Drury Quarry Sutton Block – Comments Tracker

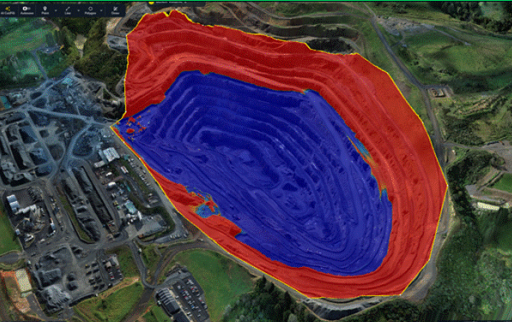
59	Andrew Rossaak (Morphum)	Freshwater and Terrestrial Ecology	<u>Wetlands</u> The assessment of potential values does not meet the assessment of values required under the NPS:F	YES	No		This response is based on the Compulsory Values set out in Appendix 1A of the NPS-FM for freshwater management units. Section 3.3 of the EclA sets out the current ecological values of the streams and wetlands. Section 5.3.2 of the EclA report sets out the stream and wetland potential value for aquatic habitats within the Sutton pit area assuming good land use practices within the current land use. The uplift in values considered include ecosystem health (Value 1 in Appendix 1A).

Human Contact (Value 2 in Appendix 1A) is considered negligible. The impacted stream and wetlands are small non-swimmable streams located within an active quarry site. They do not support, or previous had the potential to support, recreational activities (such as boating, water skiing or swimming). Threatened species (Value 3) is considered in Section 3.4 of the EclA, as part of the assessment of assessing stream and wetland habitats and values. The only At-Risk species identified was the Longfin Eel, which has been considered in the potential value assessment. Mahinga kai (Value 4) has also been taken into account in Section 3.4 of the EclA report.	
60	Andrew Rossaak (Morphum)	Freshwater and Terrestrial Ecology	<u>Wetlands</u> Wetland hydrology may be impacted for wetlands 2a south, 3 and 8 given the area of influence provided the Ground and Surface Water Report. An assessment for the potential loss of hydrology on these wetlands and adaptive monitoring is expected.	YES	No		The proposed dewatering is not expected to cause adverse effects on the hydrology of wetlands (refer to Section 3.3 and 4.7 and Figures 6 and 7 of Groundwater and Surface Water Report (Technical Report L). This is because the wetlands are sustained by shallow and perched groundwater systems that are hydrogeologically separate from the deep, regional greywacke aquifer proposed to be dewatered. The zone of influence relates only to the regional groundwater table in the greywacke. Potential effects on the shallow or perched groundwater are predicted to be limited to areas immediately adjacent to the pit, where shallow groundwater may be locally intercepted by quarry cuts along the footprint. Wetlands 3 and 8 are set back from the quarry footprint, therefore, no effects on these wetlands shallow groundwater systems are anticipated. Wetland 2a adjoins the southern extent of the wetland, and it's possible the pit excavation will intercept the shallow groundwater system. To mitigate the effects on Wetland 2a hydrology, an augmentation programme is proposed for Stream 4 and Wetland 2a (refer to Sections 9.9.3 and 9.97 of the AEE Report). In addition, ongoing assessment and monitoring of the hydraulic conductivity between wetland 2a and the upper portions of the pit slopes is proposed and required under consent Condition 30(d). This will inform setback adjustments or
